## **Addendum No. 2**

### **Petaluma Community Sports Fields Wetlands Mitigation and Bioretention Rehabilitation Project City Project No. C14501607**

Date: June 30, 2025

M-2  
OF 6

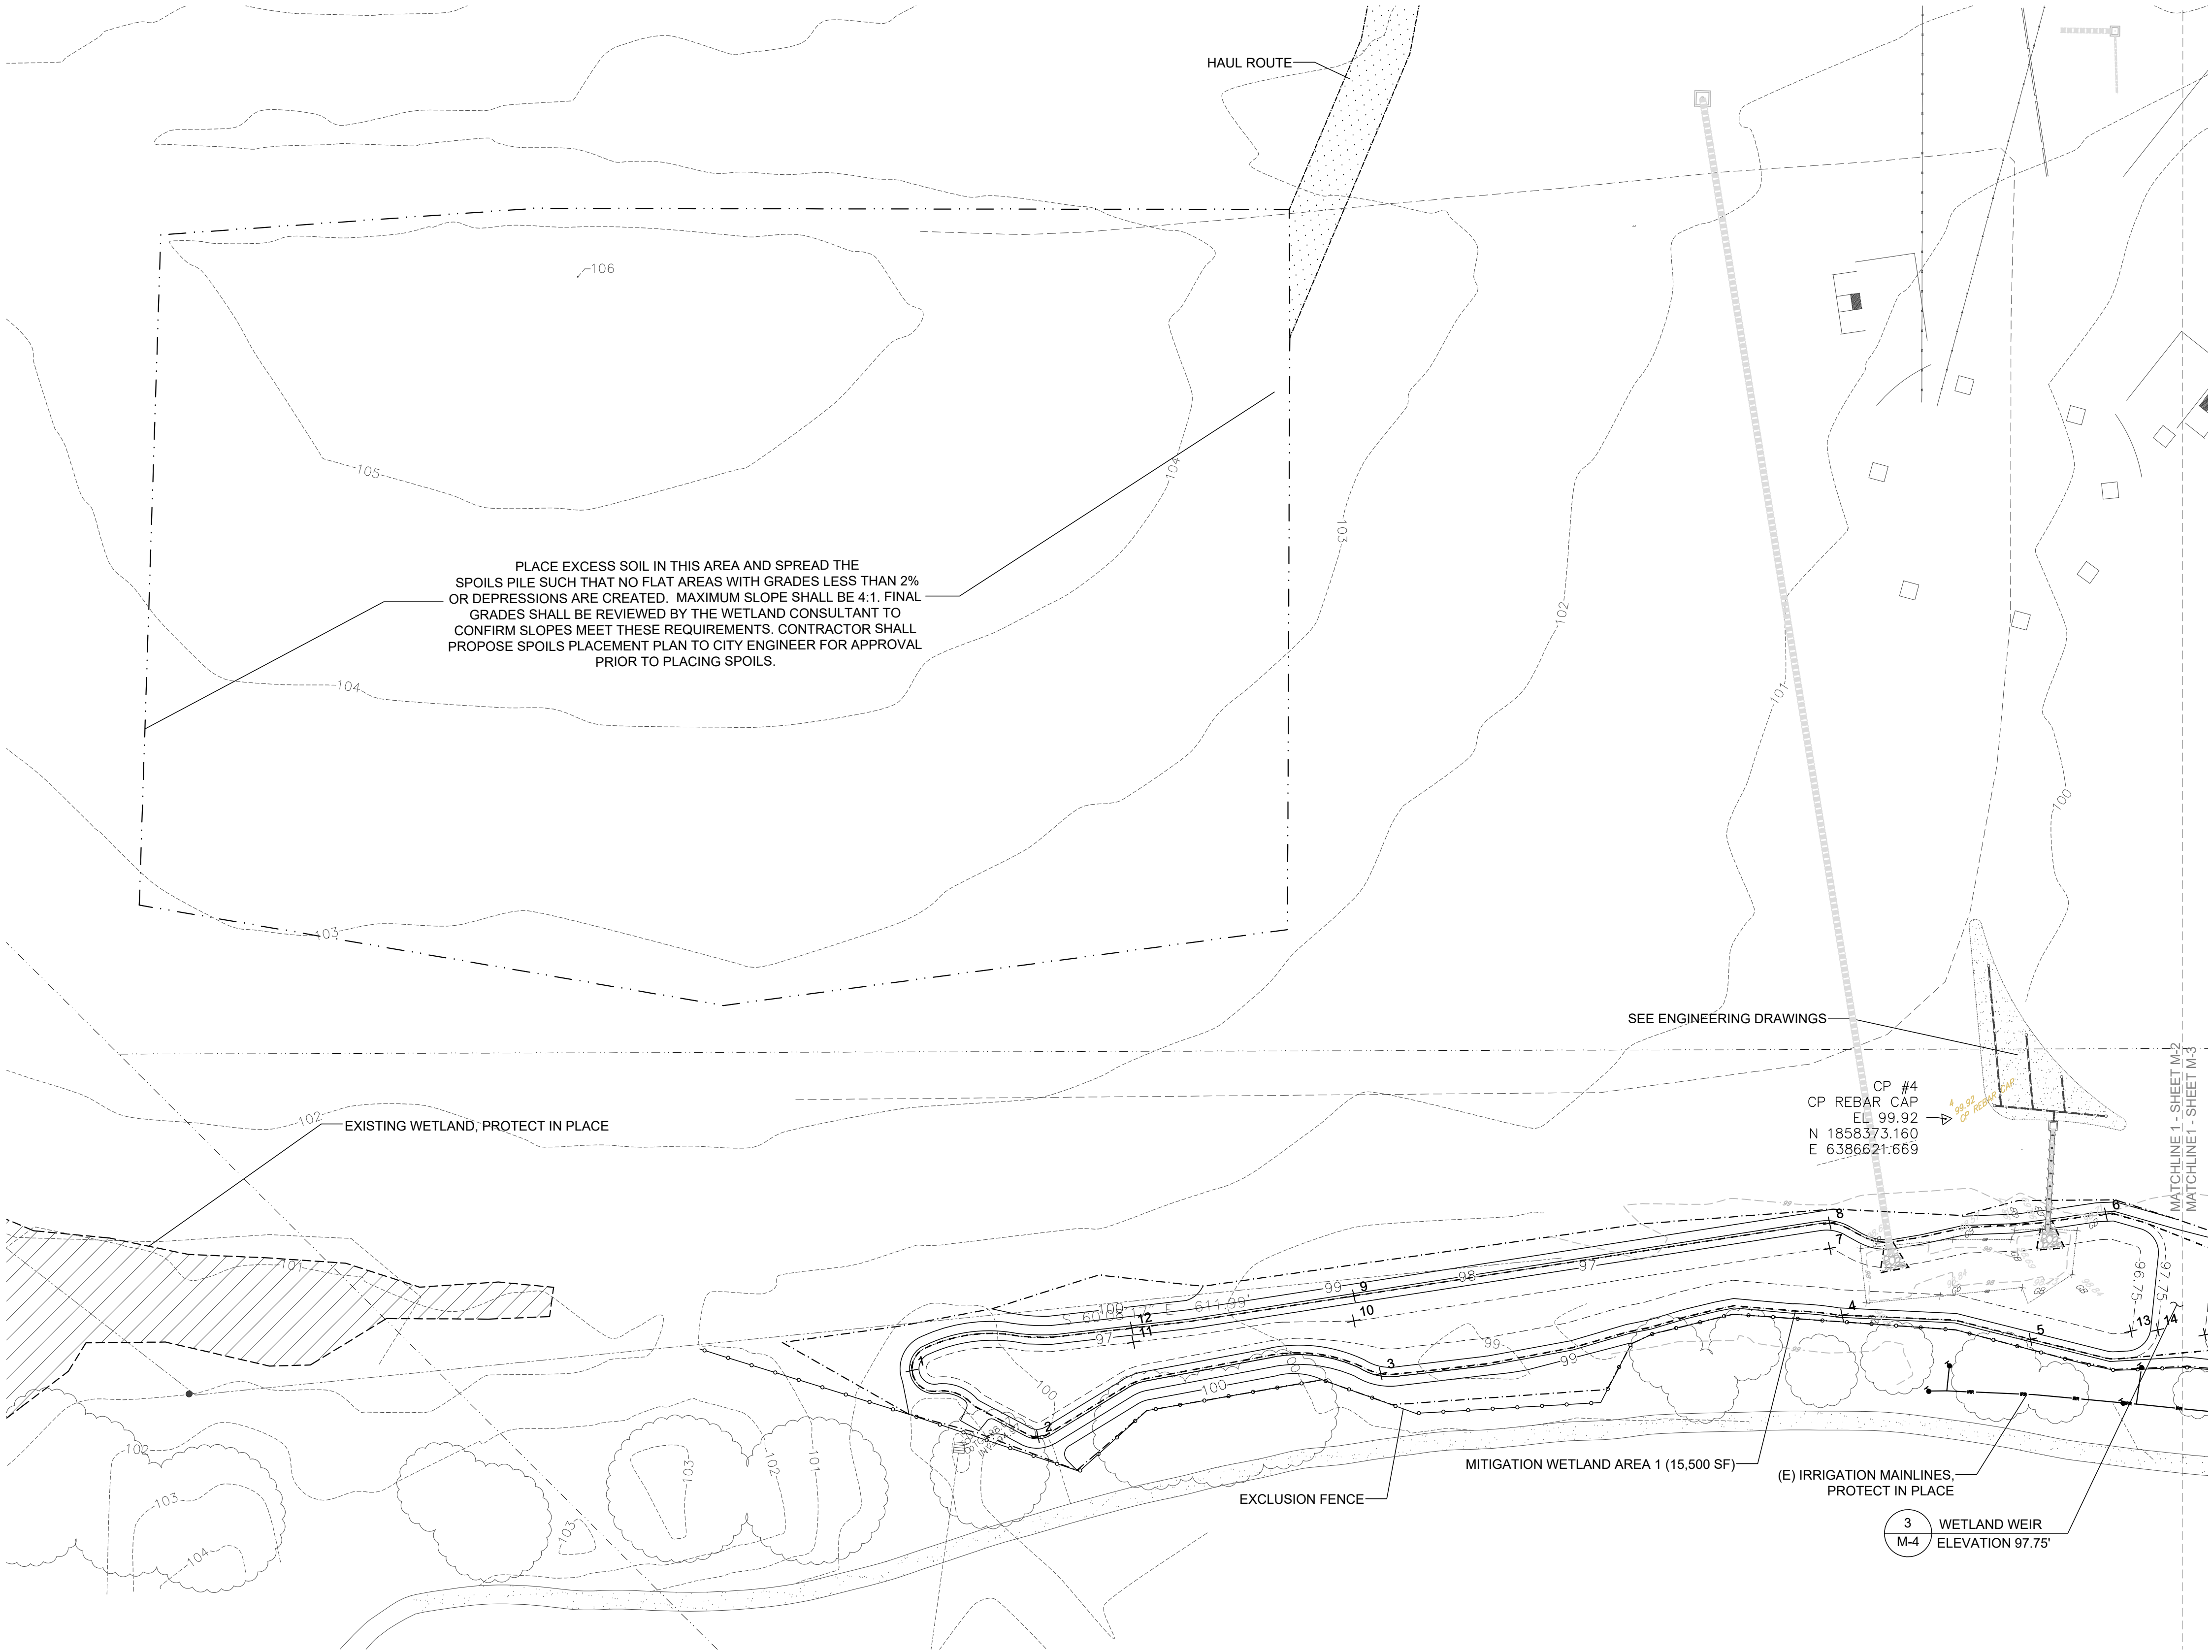
1. Delete Sheets M-1, M-2, and M-3, and replace them with sheets M-1, M-2, and M-3 included in this Addendum No. 2 package.
  - a. Changes to the sheets include adding alternative haul route path and revising survey information.

9) **Question:** It appears that there are 2 sets of existing grades on the plans. Which one is correct? Please advise.

**Answer:** Sheets M-2 and M-3 have been revised to show only the correct survey information. The other sheets did not require correction. (SEE ATTACHED)
